PD Modification Application: PD 25-0582
Zoning Hearing Master Date: February 23, 2026
BOCC Land Use Meeting Date: April 7, 2026

AGENCY REVIEW COMMENT SHEET

REVIEWER: James Ratliff, AICP, PTP, Principal Planner

8.1 Proposed Site Plan (Full)

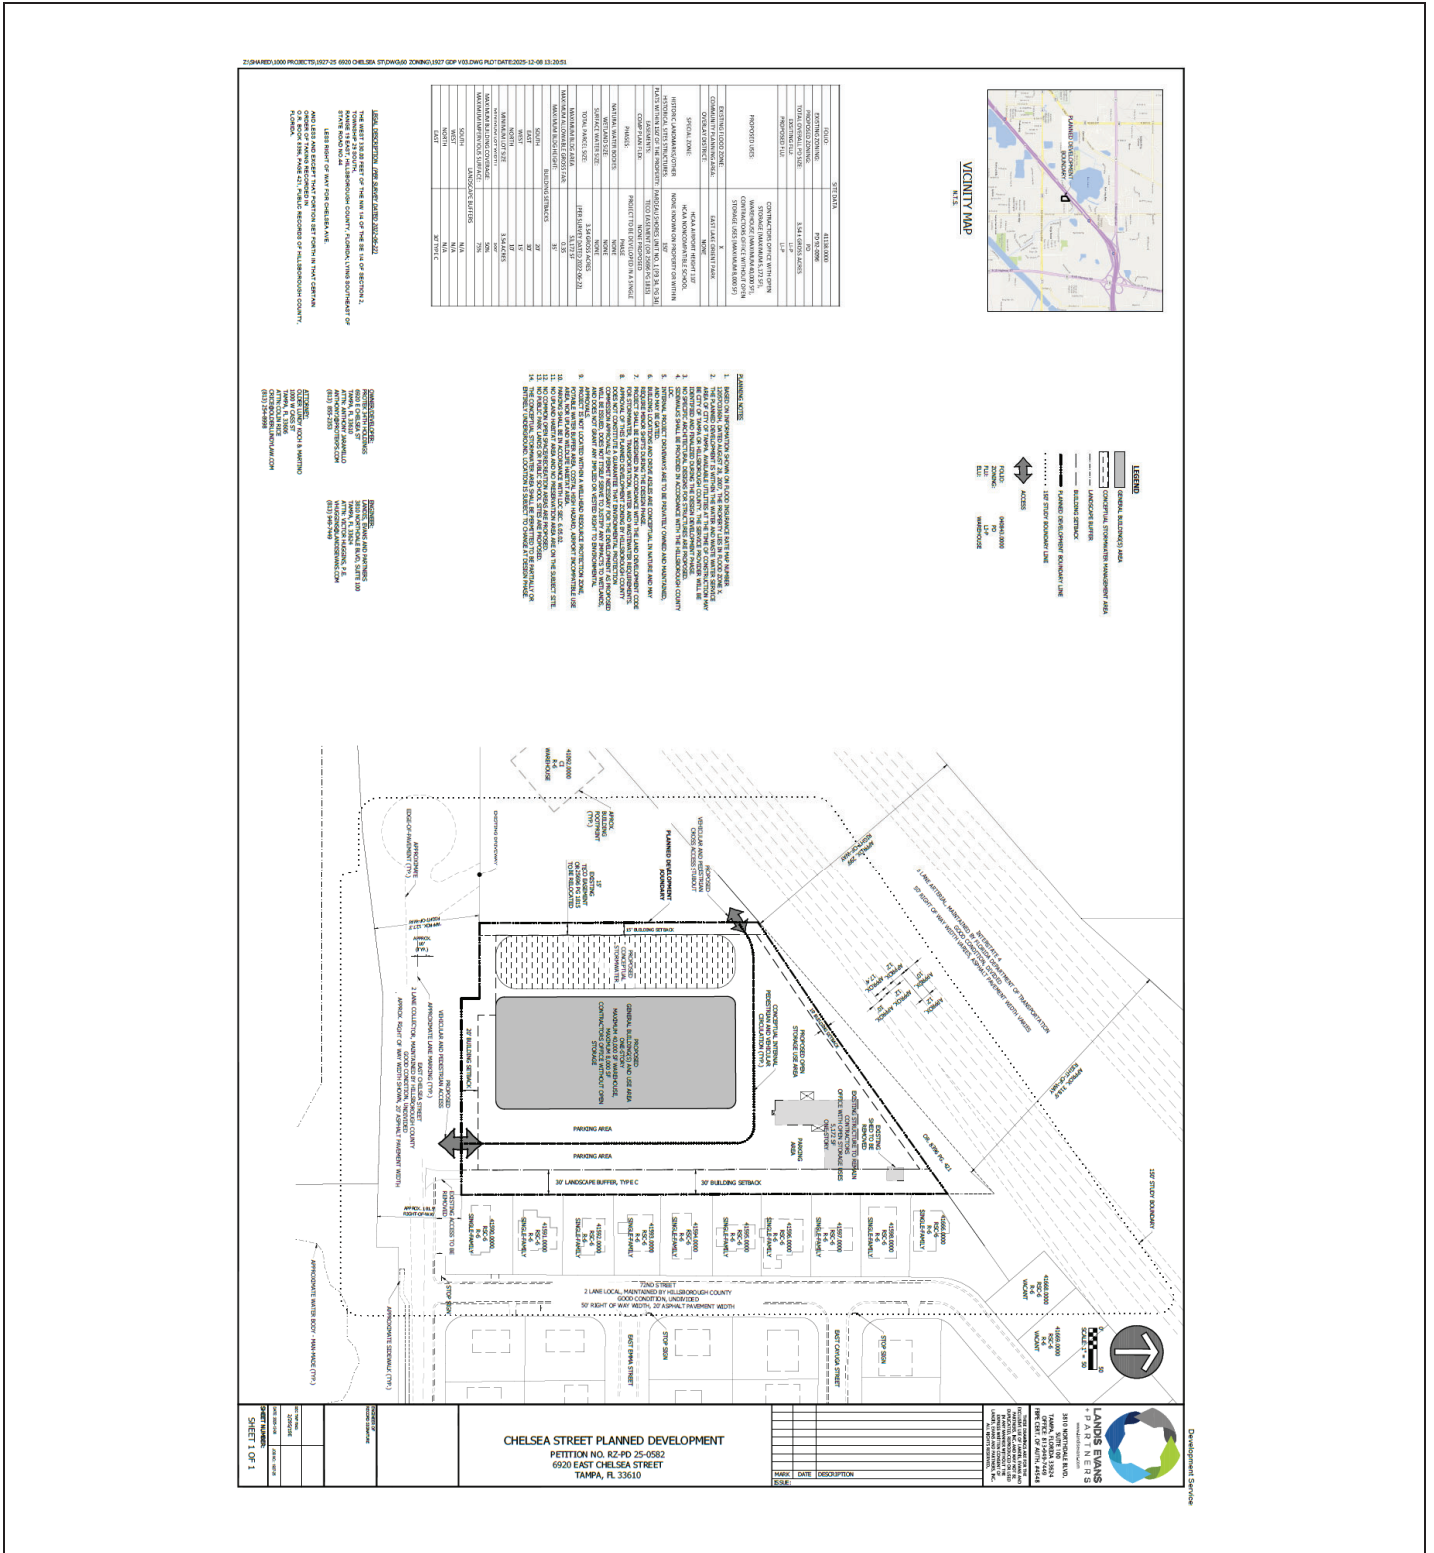
1. The project shall be limited to the following uses: Contractor’s Office with Open Storage (5,172 sq); Contractor’s Office without Open Storage (8,000 sf); and Warehouse (40,000 sf). Uses shall be developed where depicted on the site plan.

2. Open Storage accessory to the Contractor’s Office shall be permitted only west of the existing structure/contractor’s office, as delineated on the site plan.

4. A 30-foot wide buffer with Type C screening shall be provided along the eastern PD boundary, as delineated on the site plan.
5. Approval of this petition by Hillsborough County does not constitute a guarantee that Natural Resources approvals/permits necessary for the development as proposed will be issued, does not itself serve to justify any impacts to trees, natural plant communities or wildlife habitat, and does not grant any implied or vested right to environmental approvals.

8. The project shall be served by and limited to one (1) vehicular access connection to E. Chelsea St. All other existing connections shall be closed, with ditches and sod restored. Additionally, prior to or concurrent with the initial increment of development, the developer shall construct a vehicular and pedestrian cross access stubout along the project's western boundary, as shown on the PD site plan.

PROTEK PD REZONING (PD 25-0582)
Connection Spacing Exhibit

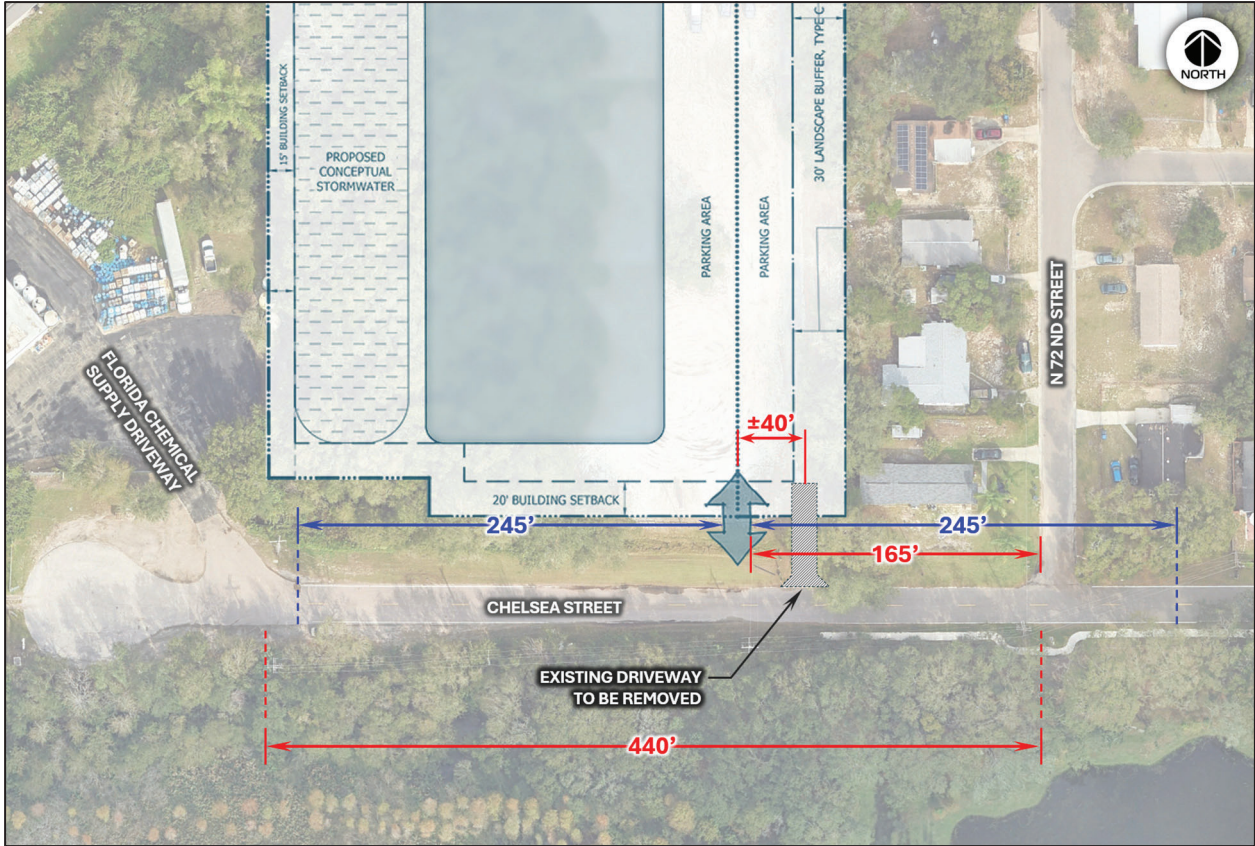
In consideration that Chelsea Street is a collector roadway, the applicable minimum connection spacing criteria is identified as 245 feet pursuant to LDC §6.04.07 for an Access Class 6 facility (for posted speeds \leq 45 mph). Within 245 feet from the location of the planned (relocated) site access driveway connection to Chelsea Street there is one existing connection. The referenced existing connection (N 72nd Street) is located \pm 165 feet east of the planned project site driveway, on the north side of Chelsea Street; as shown in **ATTACHMENT C**.

THERE IS AN UNREASONABLE BURDEN ON THE APPLICANT The project site has approximately 330 feet of frontage along Chelsea Street, therefore, a conforming site access driveway connection to Chelsea Street cannot be accommodated, as the distance between the next westerly connection (Florida Chemical Supply Driveway) and the next easterly connection (N 72nd Street) is only \pm 440 feet. Shifting the site access driveway connection to the west to increase the spacing from N 72nd Street would result in non-conforming connection spacing to the west, and would conflict with the planned building envelope and stormwater pond for the site. Therefore, approval of this Administrative Variance is necessary such that an unreasonable burden is not unduly imparted upon the applicant.

WITHOUT THE ADMINISTRATIVE VARIANCE, REASONABLE ACCESS CANNOT BE PROVIDED The subject planned site access driveway connection to Chelsea Street cannot be located in conformance with the applicable connection spacing requirements, and the project site does not have frontage along any other roadways. Therefore, the subject driveway connection to Chelsea Street is necessary to provide reasonable access to the external roadway network. Therefore, approval of this Administrative Variance is necessary to provide reasonable access for the subject project.
